Land To Rear Of Springbank, High Street, Stoke Golding, Nuneaton LCC Highways Response Tracker

Pell Frischmann (PF) has produced this tracker setting out and itemising the comments from LCC Highways (**Table 1**) to ensure that all the comments are fully reviewed and addressed appropriately.

Description of Application: Demolition of existing dwelling and erection of 19 dwellings, formation of access and associated works

Appendix 3 – 10145-PEF-XX-XX-D-H-000011A P01 Access Road Layout

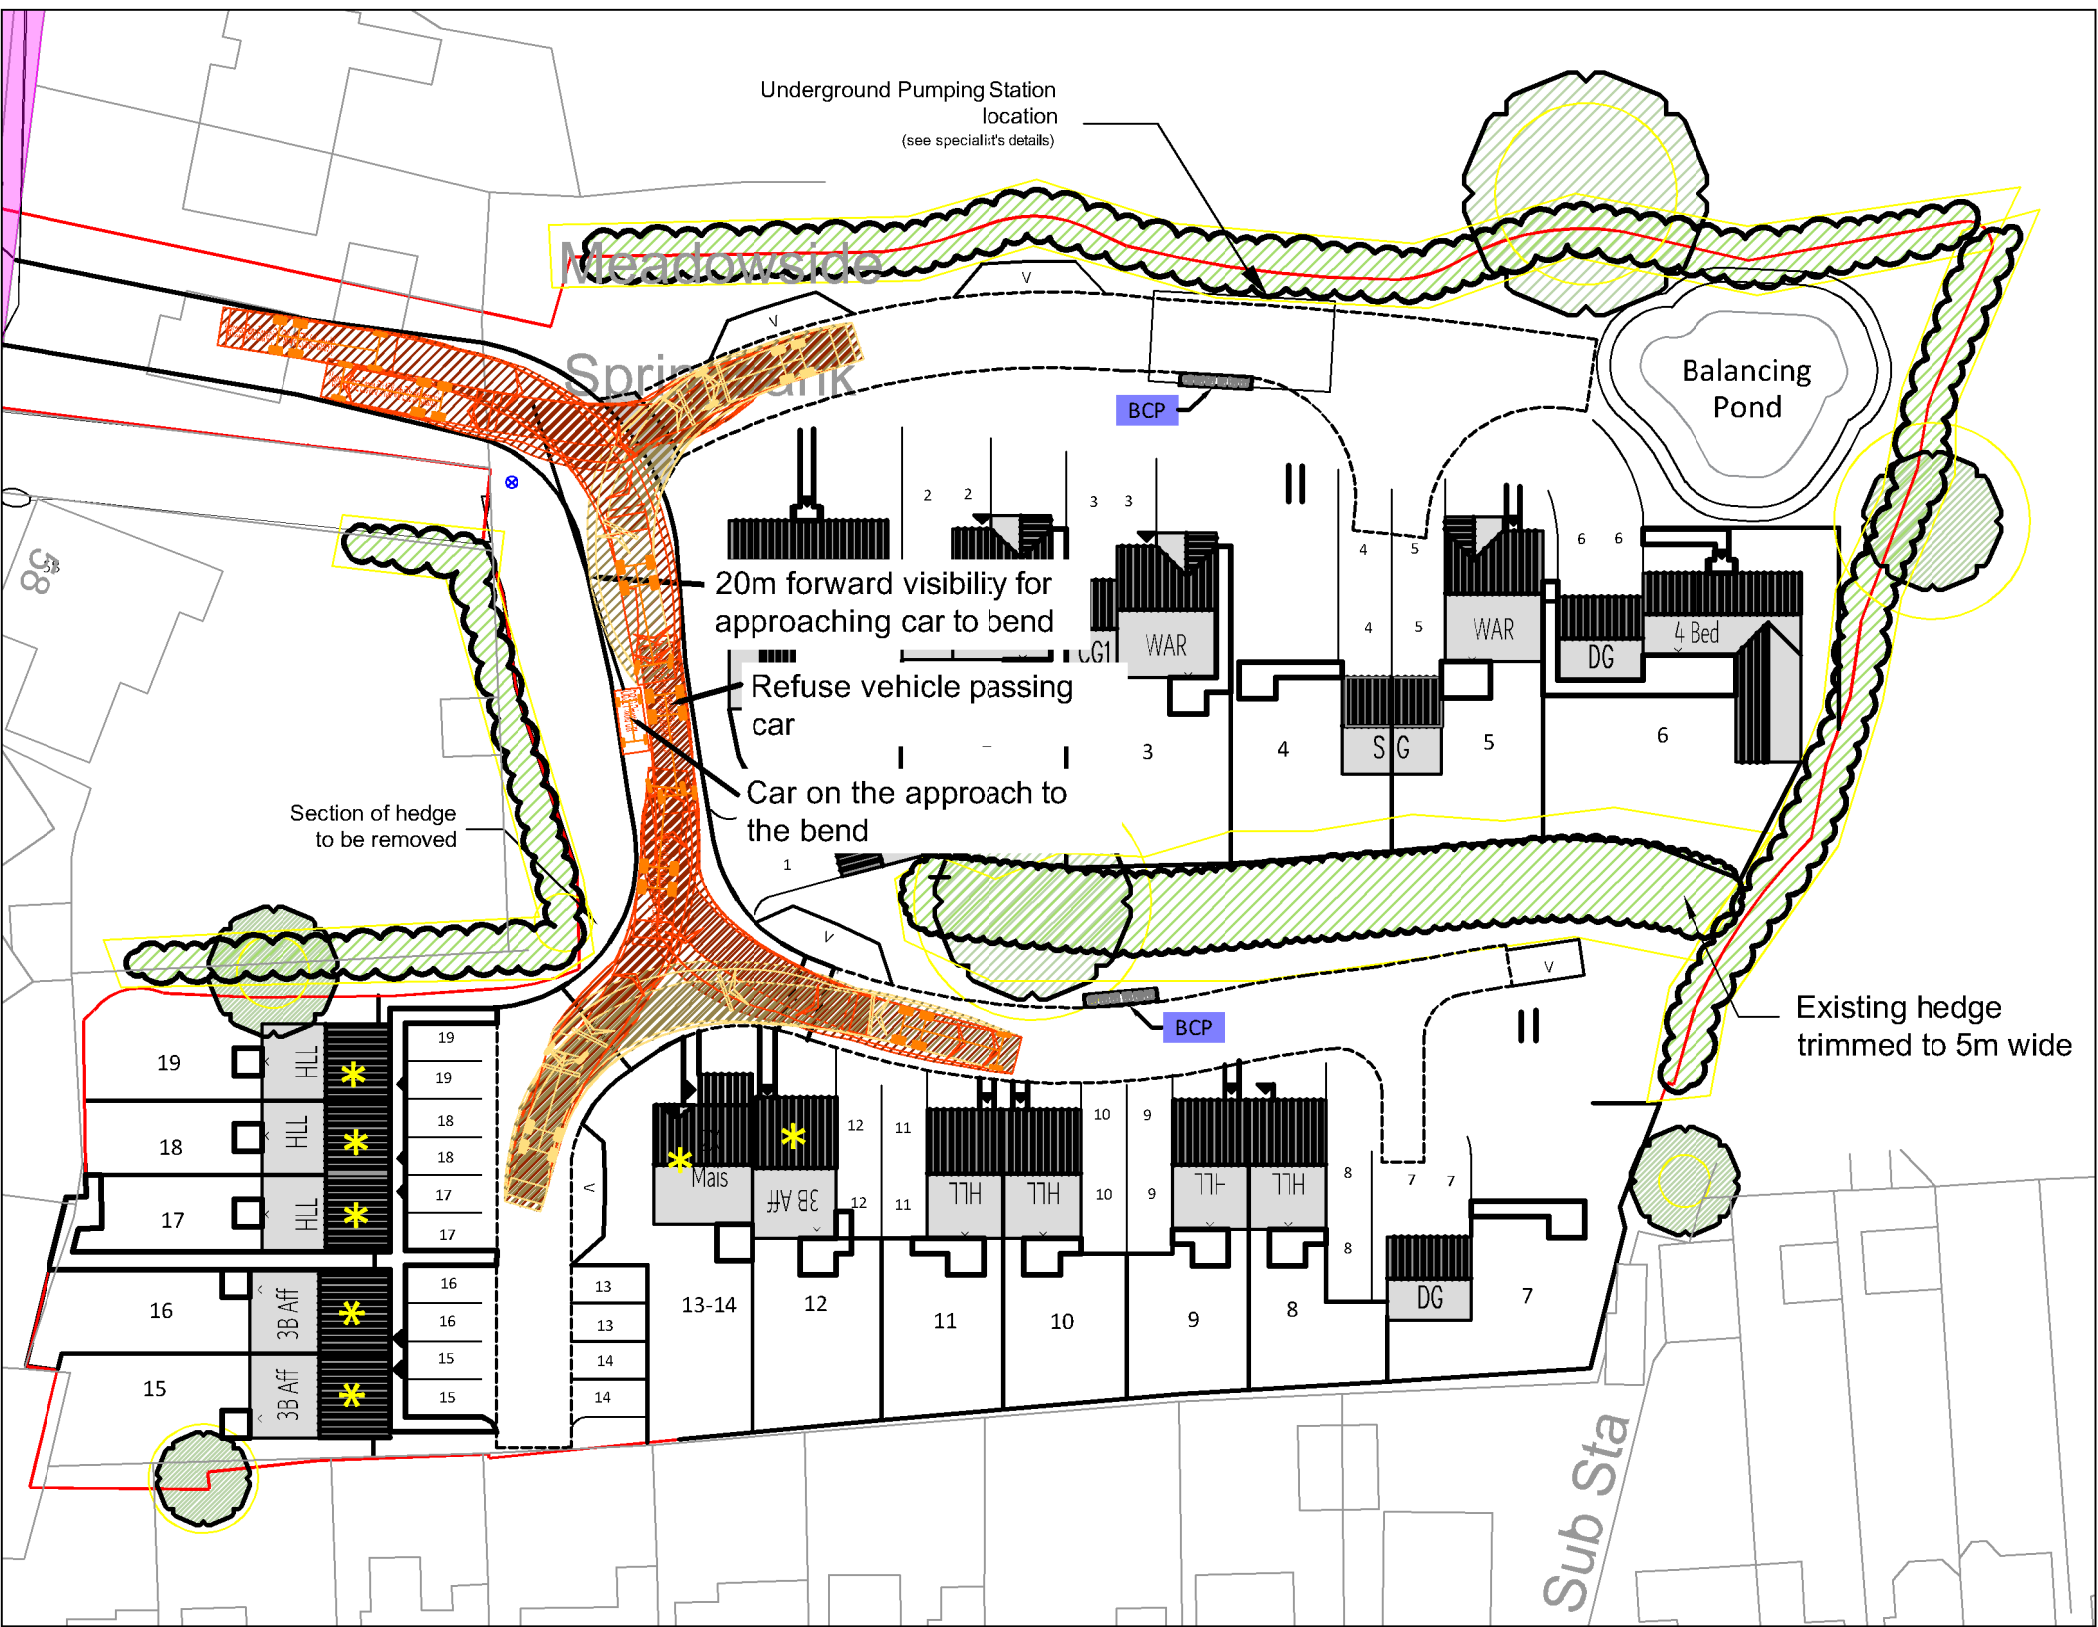
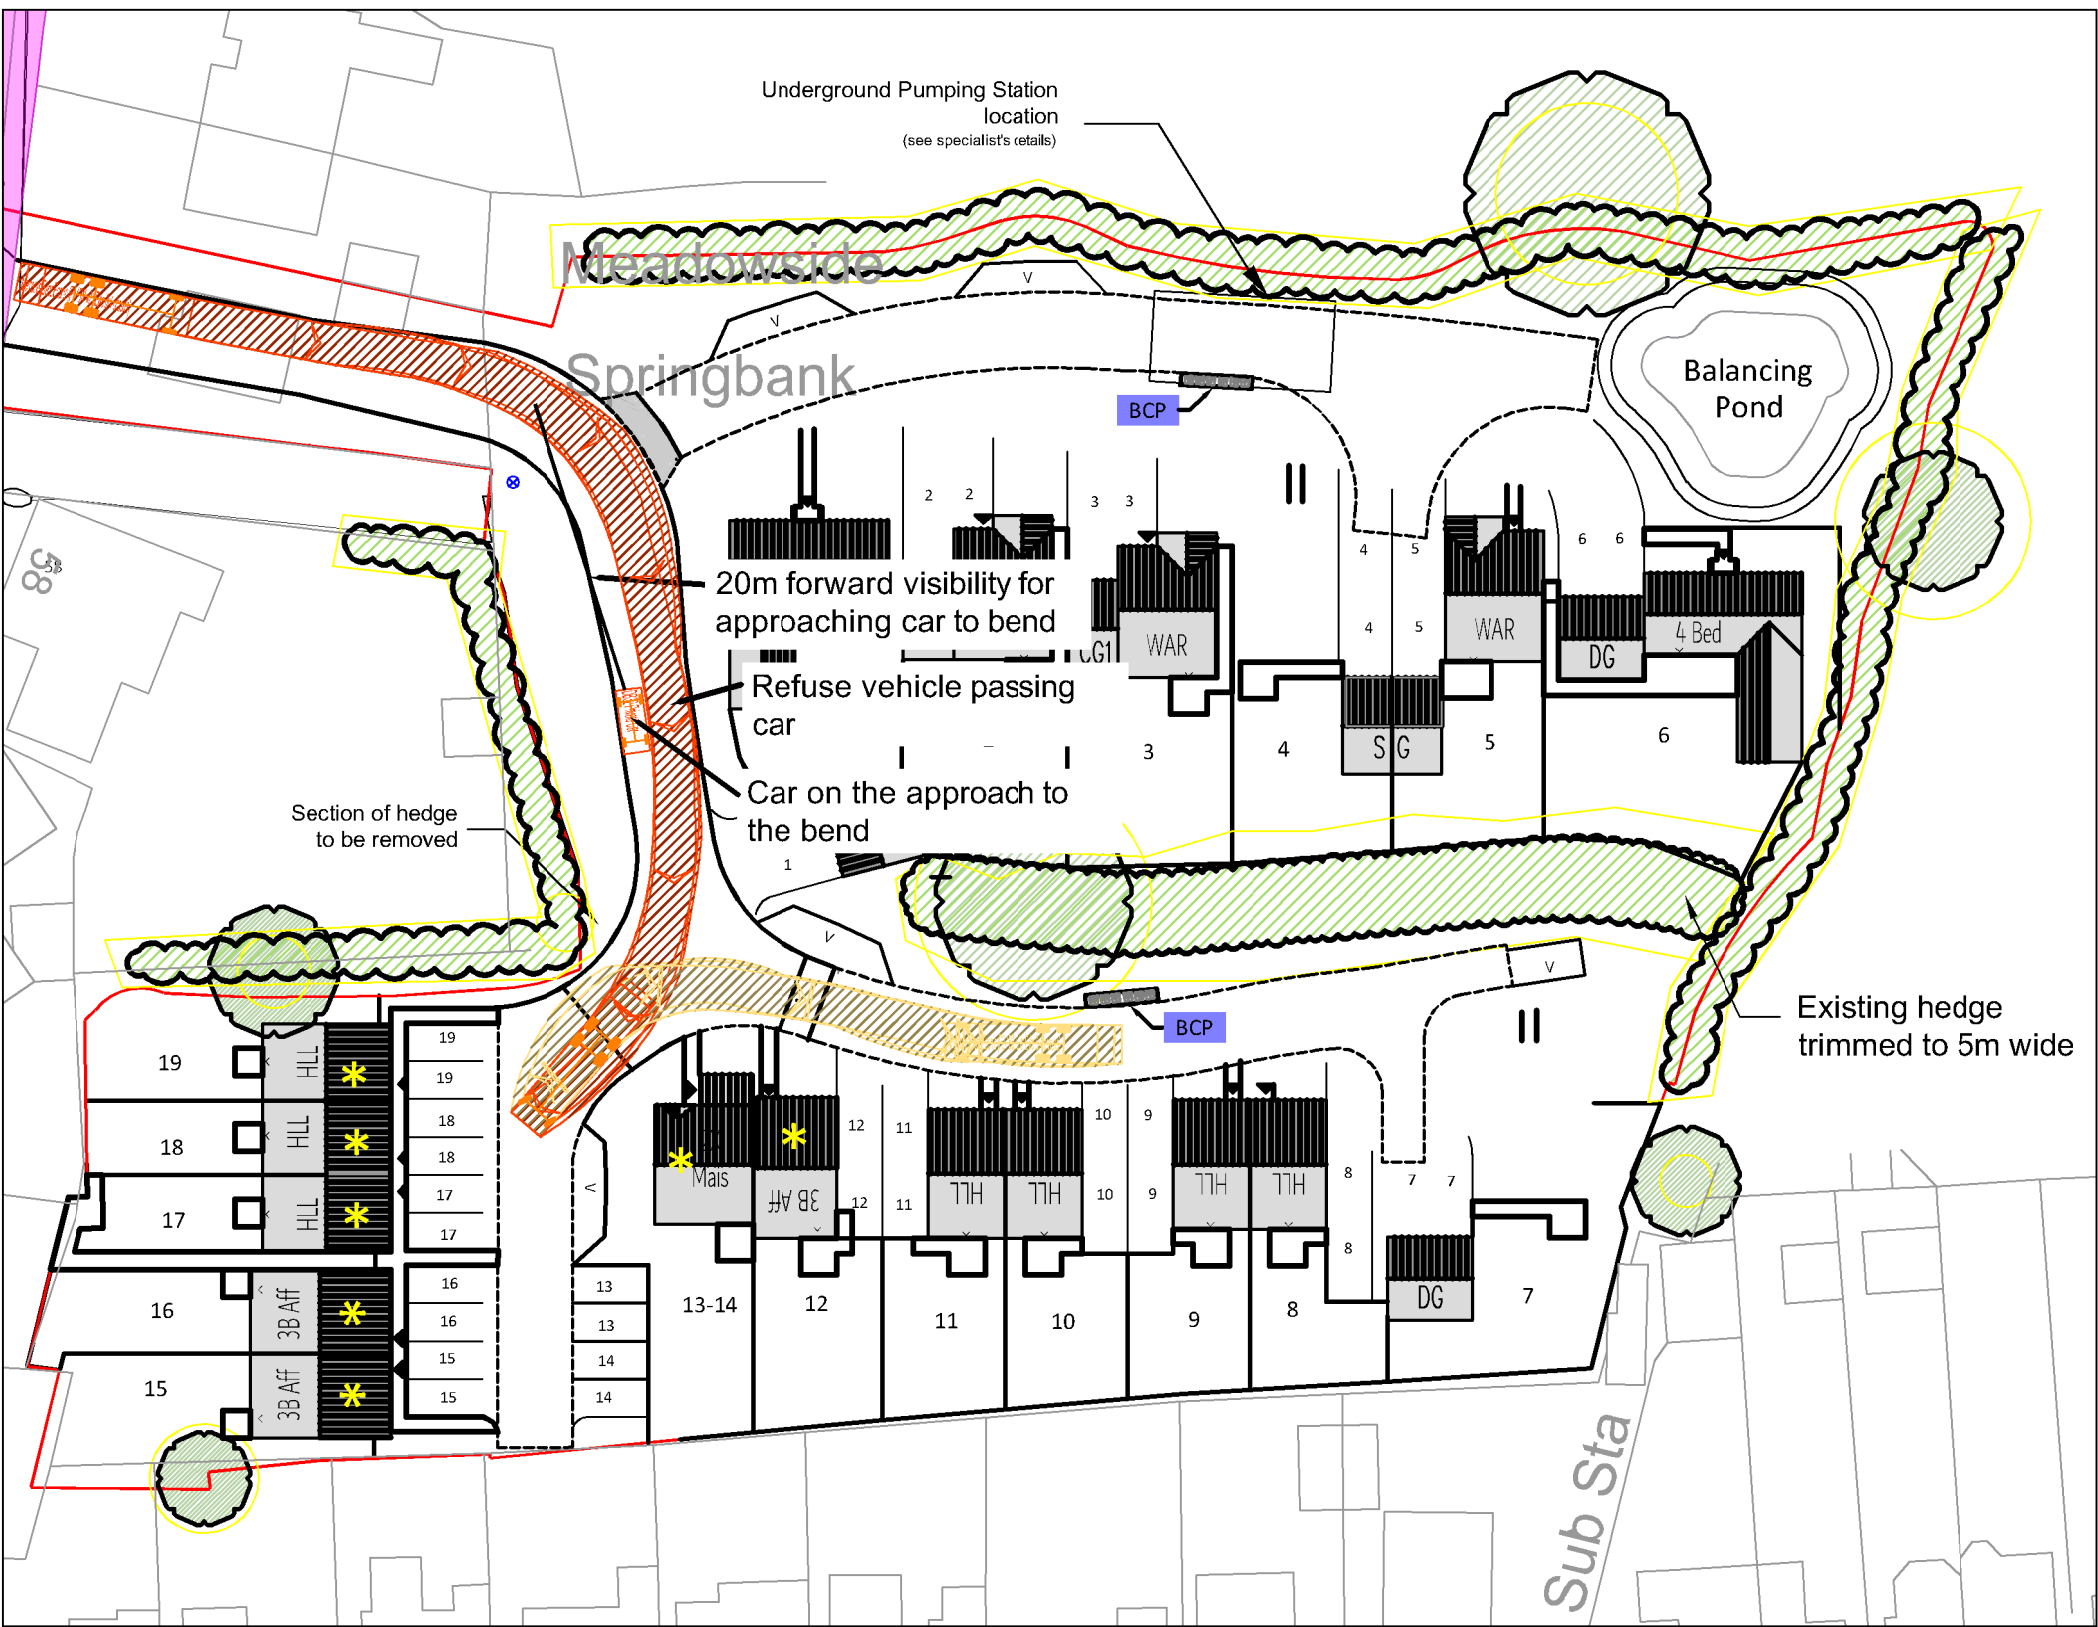
12.	Adoptability Comments The LHA consider that the internal layout does not fully accord with the LHDG and the site is therefore not suitable for submission of a S38 application post granting of planning consent as currently presented. Whilst it is not a requirement for these matters to be addressed during the planning application stage, the Applicant may wish to consider addressing the following points in order to demonstrate a layout more likely to be suitable for an application for adoption under S38: • The inclusion of bin collection points on the block paved roads serving plots 1-12 would indicate these are to be private drives. Unless amended to suit a shared surface geometry in line with Figure 3 of the LHDG the development would fall under the minimum of 6 plots fronting onto/ being directly served by the entrance road and thus be un-adoptable. • The carriageway geometry does not accord with Table 3 of the LHDG. The Applicant is required to review and adjust the layout accordingly to ensure it is compliant, making note of the maximum number of plots served from each class of road etc. Larger width carriageways would potentially be acceptable to futureproof the site and allow for expansion down the line. • Speed control measures will need to be designed into the road layout. In this instance, the maximum distance between speed control measures, junctions or 90-degree bends is approx. 60m. Further information can be found in the Leicestershire Highway Design Guide (LHDG) Table 20. • Further to the comment above, the minimum plateau length of vertical speed control measures should be 8m, and the ramps should not conflict with the access drives of the dwellings. For further information, please see LHDG, Figure 31. • The turning heads are not designed in accordance with the LHDG, subsequently they will all need amending. Please see Figure 12 of the LHDG for further information. • 2m footways should be provided on both sides of the carriageway, particularly where there are plots fronting onto the highway. A 1m service margin can be provided at location(s) where 2m footways are not necessary, for example at the end of turning heads. • 2m footways are also not required at the end of turning heads; a 1m service margin will suffice.	Main spine road length is 75m It is a private drive serving up to 25 dwellings with a 5.5m wide access road for 5m at the junction with High Street to accommodate refuse vehicle then reduces to 5m for the rest of its length. At the first bend it has been widened in accordance with <i>Table 7: Residential roads – widening on bends</i>. It provides a 17m forward visibility based on 15mph design speed. It has a turning head end at the end in accordance with Figure 11. Plots 1 to 6 road length is 62m = 5m Junction layout in accordance with Figure 14 and a junction visibility splay of 2.4 x 17m. No turning head facility required for refuse collection. A turning head facility is required for a fire tender. The turning head is in accordance with Figure 11. Plots 7 to 12 road length is 47m = 5m No turning head facility required for refuse collection or a fire tender. The turning head is in accordance with Figure 17 for cars. Plots 13 to 19 road length is 27m = 5m No turning head facility required for refuse collection or a fire tender. For a 15mph road speed control features is required every 40m. The 90-degree bends acts as a speed control feature and is 40m to the junction with High Street and 40m to the turning facility at the end of the spine road. Not required The revised layout reflects the turning head dimensions as set out in Figures 11 and 17. Private drives serving up to 25 dwellings do not require footways. Private drives serving up to 25 dwellings do not require footways.

Ref.	LCC Comments	PF Response
	• The Applicant should provide refuse vehicle tracking of the site using the attached specification. • There are a few cases of isolated parking in relation to the dwellings, which may result in on-street parking occurring due to poorly positioned spaces. It is suggested parking provision for Plots 1 and 14 is reviewed. The Applicant is advised that the above matters are expected to result in changes to plot positions; should the application be determined with the site layout as currently presented and the Applicant subsequently wishes to put forward the roads for adoption under S38, this could result in the requirement for a Non-Material Amendment or S73 Variation of Condition application being required to be submitted to the LPA to meet the required LHDG standards. The following elements of the proposals do not accord with the LHDG, however, as these are not expected to alter plot positions, it is expected that these can be addressed as part of a future S38 technical appraisal process: • The radii at the junctions and turning heads should be detailed on the plan, to ensure they are in accordance with the LHDG. • The junction radii should be 6m for any side roads. For further information please see Table 9 of the LHDG. • The developer should also note that radii for turning heads should typically be 8m/ 10m. Please see Figure 12 of the LHDG for further information. • The Applicant should remove the visitor parallel parking bays on the road west of plot 1. The Applicant is advised to note the following points: • Grassed 1m service margins are not acceptable, any grass verge areas should be a minimum of 2m in width and be in excess of 10m² in area. • Tactile paved uncontrolled pedestrian crossings should be provided and shown at junctions/where appropriate. e.g. at PROW crossings. • Consideration of root barrier/deflection treatment will be required when proposing trees/shrubs adjacent to the footway. • At this stage it is not possible to comment on the vertical alignment, drainage, materials or proposed construction details.	The revised drawing shows the tracking using a 11.7m long refuse vehicle. - The dimensions and radii are now shown on the revised plans. The internal and site access junctions are private drives serving up to 25 dwellings and therefore drop kerbs have been proposed in accords with the design standards as set out in Table 13. The revised layout reflects the turning head dimensions as set out in Figures 11 and 17. The parallel visitor parking has been relocated. This has been considered and tactile paving is not required at the internal junction or the proposed site access junction as these are private drives serving up to 25 dwellings.

Ref.	LCC Comments	PF Response
	Should the Applicant wish the double garages to count towards parking provision, The Applicant will need to amend the measurements to accord with the LHDG specifications. The current measurements would only count towards one parking space within each double garage. Taking this into consideration, plots one, six and seven to which they apply, would have the minimum required parking spaces if the current double garage measurements remain. Swept Path Assessment, drawing number 110145-PEF-ZZ-XX-D-H-00006, Rev P01 states that Plot 7 garage and car parking spaces to be relocated. Given this is a full application, the LHA require an updated plan to demonstrate this. Swept Path Assessment, drawing number 110145-PEF-ZZ-XX-D-H-00006, Rev P01 demonstrates that a LCC specified refuse vehicle, which is 11.2m long (Phoenix 2 Duo Recycler) and an DB 32 Fire Appliance measuring 8.6m long can safely manoeuvre and turn around within the site via the internal spine road. It also shows that the fire tender can access each dwelling within a distance 45m and does not need to reverse more than 20m.	Updated. Refuse tracking and Fire Tender tracking is acceptable. PF has re-tracked it as a result of the changes to the internal road layout.
